DA Access Report

21050

198 Bennett Road, St. Clair, NSW

This Access Compliance Report is to accompany a Development Application for the development proposed at 198 Bennett Road, St. Clair, NSW

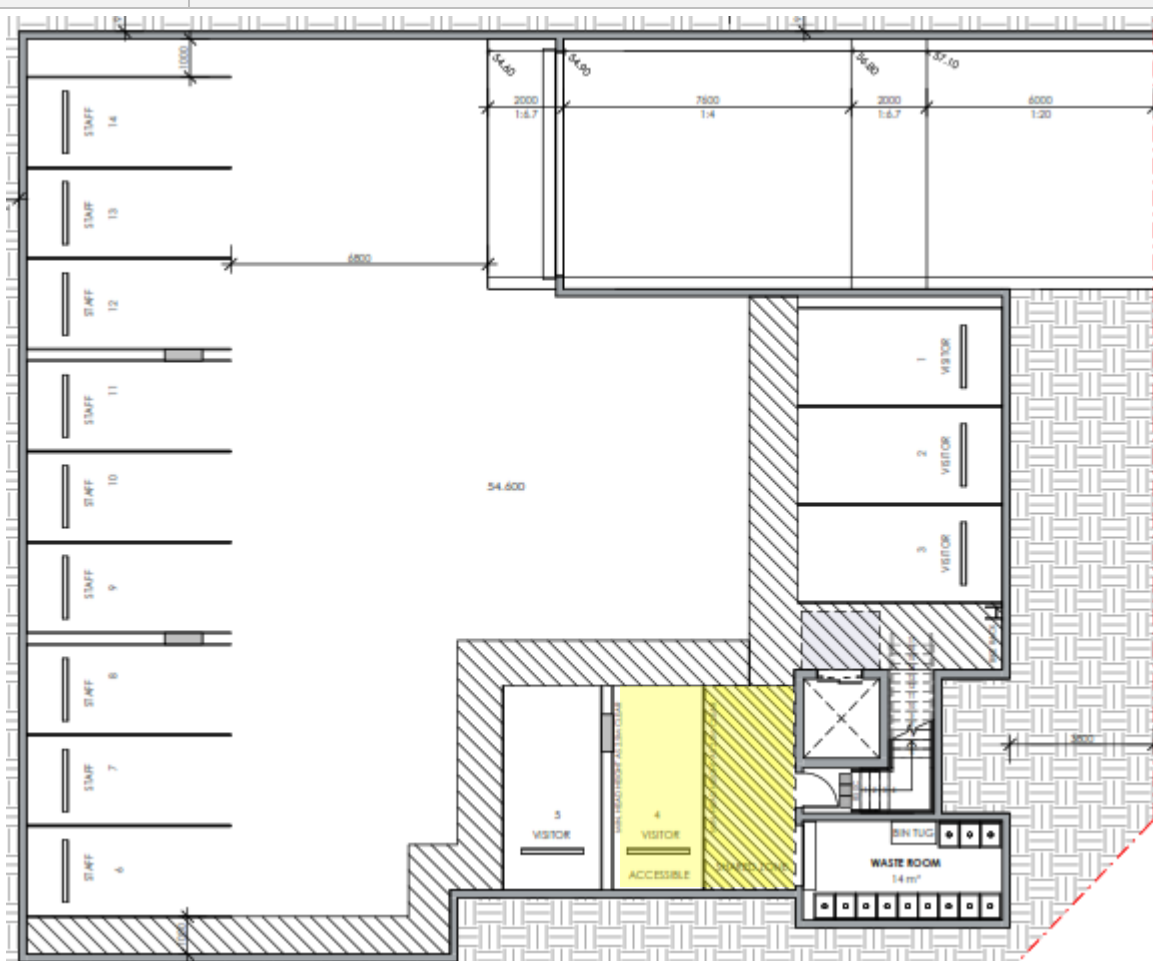
<b>Requirement</b>	<p><b>All common use doorways and doorways to and within Accessible and Adaptable units</b> to comply with AS1428.1.</p> <p>Where accessible pedestrian entry has Multiple doorways:</p> <ul style="list-style-type: none"> <li>- At least 1 to be accessible if 3 provided</li> <li>- At least 50% to be accessible, if more than 3 provided</li> <li>- Where doorway has multiple leaves, at least 1 leaf is to have clear opening of 850mm (excluding automatic doors)</li> </ul>
<b>Compliance Comments</b>	<p>Complies with spatial requirements.</p> <p>In common use areas, all single hinged doors and in case of multiple leaf doorways, at least 1 operable leaf is required to provide a clear opening of 850mm with the door circulations spaces as per AS1428.1-2009.</p> <p>Note that the circulation spaces to have a maximum floor grade of 1:40 (doorway threshold ramps are permitted within the circulation space).</p> <p>Sliding doorways to be provided with recessed floor tracks to enable flush transition from the inside of the building.</p> <p>Where there is an external level difference at the door threshold, the maximum level difference can be 35mm if provided with a 1:8 doorway threshold ramp.</p> <p>Note that the common use bin area has been provided with a roller door. This door will be required to be automated or alternatively provided as an accessible hinged door.</p>

[Image description: Plan of Basement Level above shows the provision of Accessible parking space]

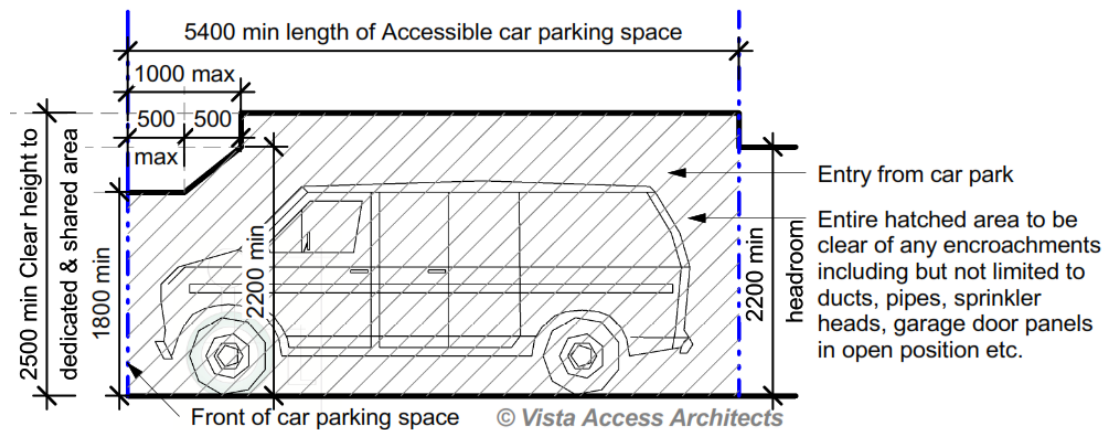
<b>BCA Part D3.5 Accessible Carparking</b>
<b>Requirement</b>	<b>Class 9b</b> School - 1 Accessible car parking space per 100 spaces provided Other assembly building - 1 Accessible car parking space per 50 spaces provided and then additional 1 Accessible car parking space per additional 100 spaces provided
<b>Compliance Comments</b>	Complies. Total number of Accessible parking spaces required / provided in the development = 1. Detailed features of the accessible parking space to be verified at CC stage of works.

### Compliance Comments

Complies with spatial requirements

Details to be verified at the CC stage of works.
